## Application for Works Approval

**Works Approval Number** W3134/2025/1

**Applicant** Upcycle Tyre Services Pty Ltd

**Premises** Upcycle Tyre Services  
62 Burlington Street  
Naval Base WA 6165

Figure 1: Stormwater / firewater drainage systems

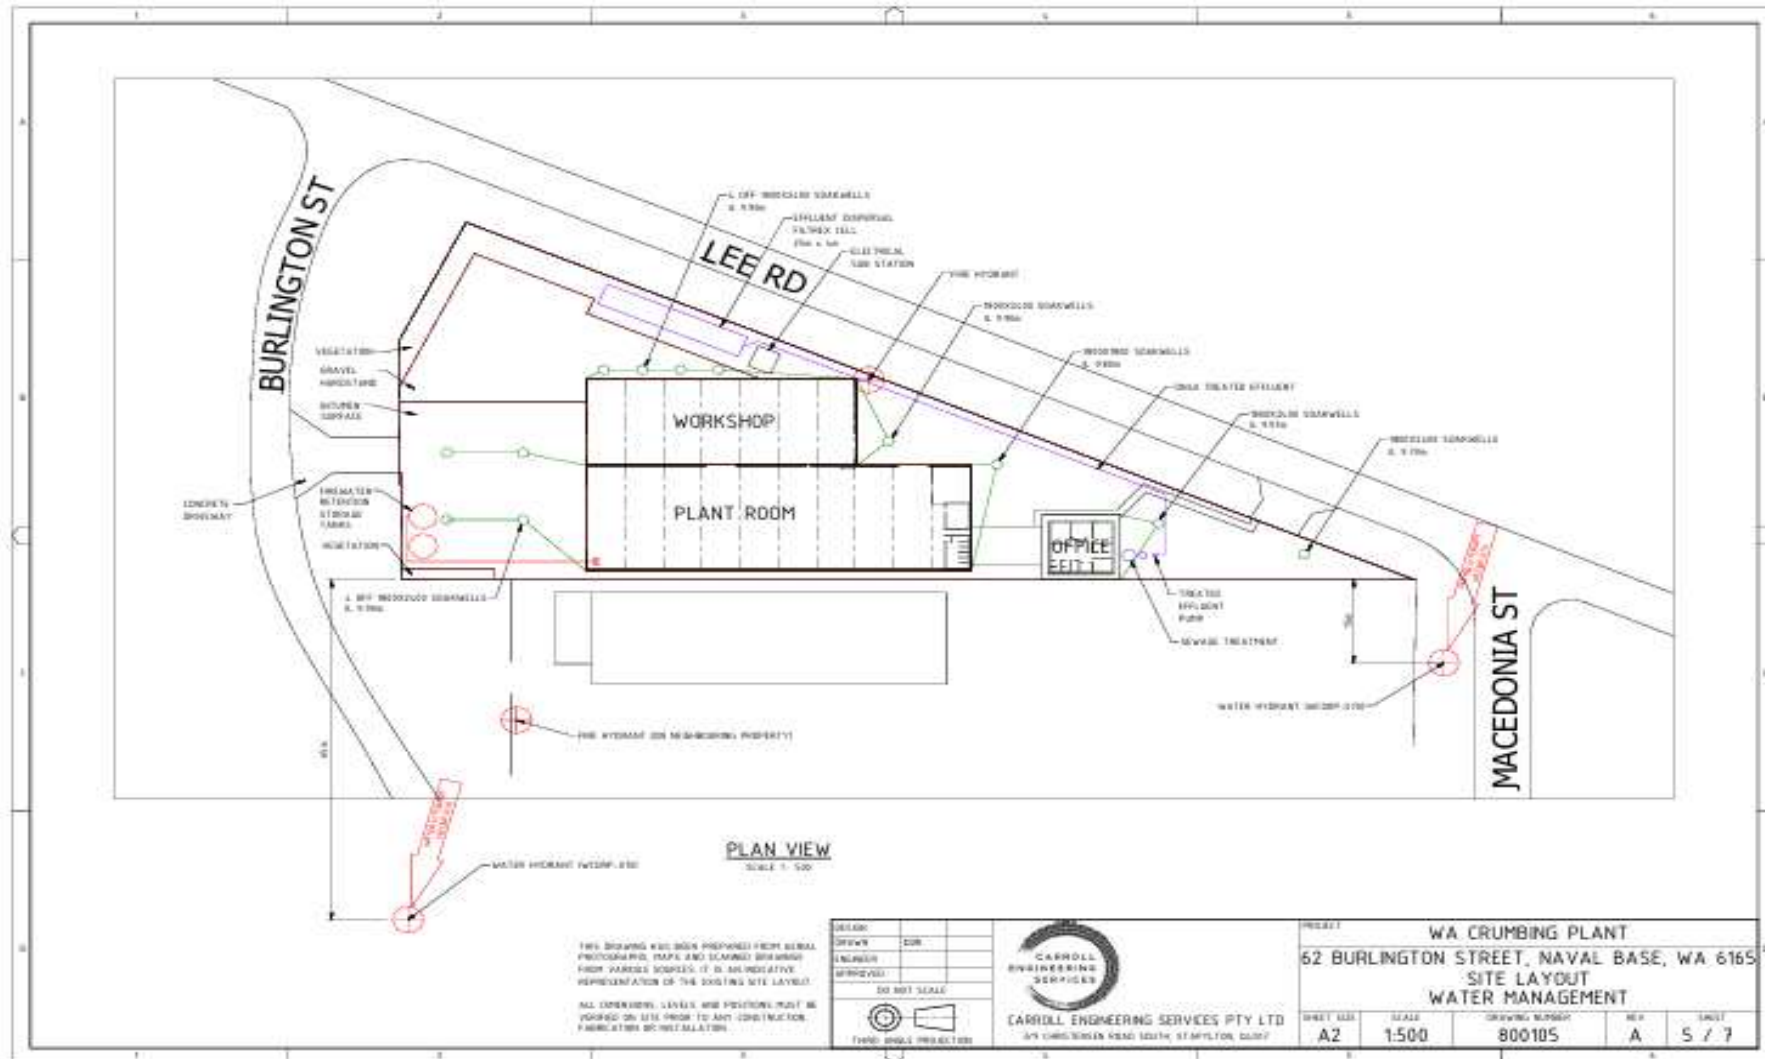
The drainage network at the Premises is designed to contain and manage stormwater through a system of soak wells. Surface runoff from the bitumen hardstand and concrete areas is directed to a series of distributed soak wells. The network consists of multiple 1800mm x 2400mm soak wells and 1800mm x 1800mm soak wells positioned at key drainage points around the workshop, plant room, and driveway areas. The site also utilises an Effluent Dispersal Filtrex Cell (25m x 4m) for treated effluent management. Figure 1 provides an overview of Stormwater / Firewater drainage systems at the Premises.
